From: mark unwin [REDACTED]
Sent: 14 November 2022 12:26
To: Patrick Marfleet [REDACTED]
Subject: Bevan House, Boswell St 2022/2055/P

**RE: GOSH REDEVELOPMENT AND WEAK VAULTS UNDER
BOSWELL ST**

Re: BEVAN HOUSE, BOSWELL STREET, LONDON WC1N 3BT

Plate 1.

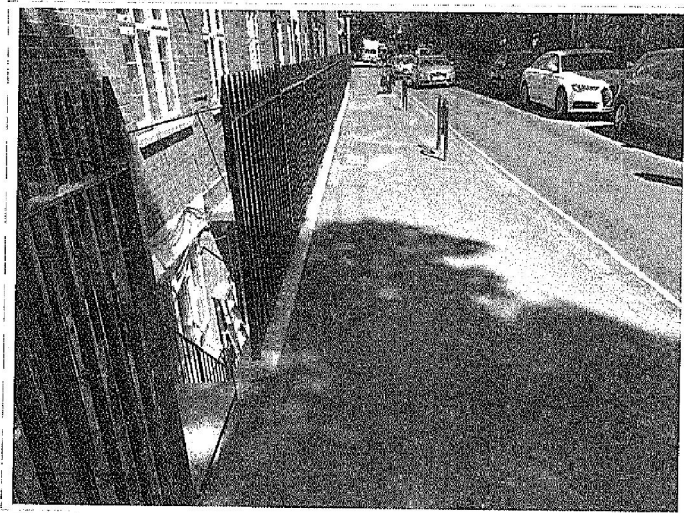
- 1.3 It should be noted that the width of Boswell Street is narrow with cars parked down one side refer to Photo 1 and this should be considered, with regards to width of any equipment that is planning to use the road as access. As can be seen in the photos there are cycle loops located on the footpath, and whilst the vaults primarily extend beneath the footpath, some of these also extend slightly further into the road. If the construction equipment needs to utilise the pathway, we would recommend contacting the Council first as the cycle loops would need to be removed to facilitate this.

Plate 2.

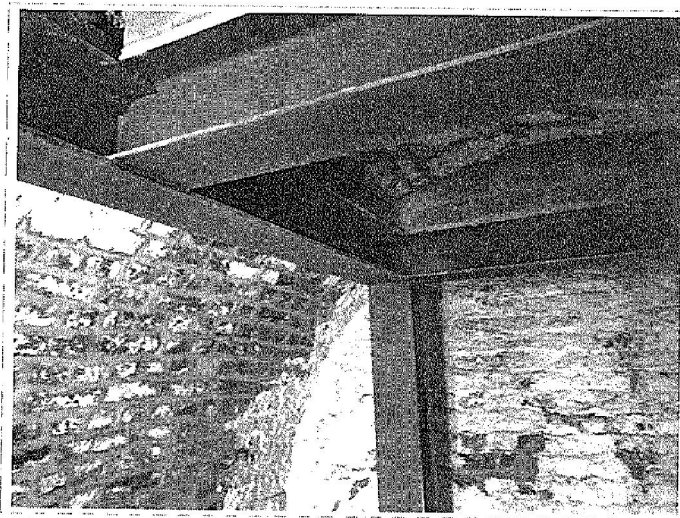
- 2.2 Whilst on site carrying out our latest inspection, we can confirm that steelwork has been installed within each of the vaults, however whilst our drawings depict bolted connections, the steelworks sections appear to all have been site welded, refer to Photos 2 & 3.

- 2.3 Whilst this detail does not match our specification, we have no concern over the strength or durability of these connections and can confirm that they are capable of carrying the original loads that the bolts were designed for.
